Rapiscan systems An X-Ray Company	Secure 1000 Radiation Emission Measurement	FORM R-0646-1 (Single Pose)
--	---	--------------------------------

Re: Rapiscan AIT System Radiation Survey Reporting

R-0646-1 Addendum (Documentation Errors)

Product Name	Secure 1000SP (Single Pose)
Serial Number	S51011002
Radiation Emission Measurement	Radiation Survey Dated: 06/23/2010
RSO Initials	[REDACTED]

Master Unit (with monitor screen)

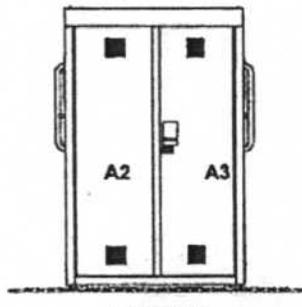
1. Technician indicated scan time as 7 seconds. Correct scan time is 3 seconds.
2. TABLE 2: Incorrect presentation of data in Column 3 for Measured Exposure. Indicated value is .1 uRem. The correct value should be 1 uRem.
3. TABLE 2: Incorrect presentation of data in Column 6 for Dose Equivalent. Indicated value is .18 uRem. The correct value should be 1.8 uRem.

The service technician should attend refresher training.

The corrected data indicates this system was operating within expected parameters. No re-survey is required for this system.
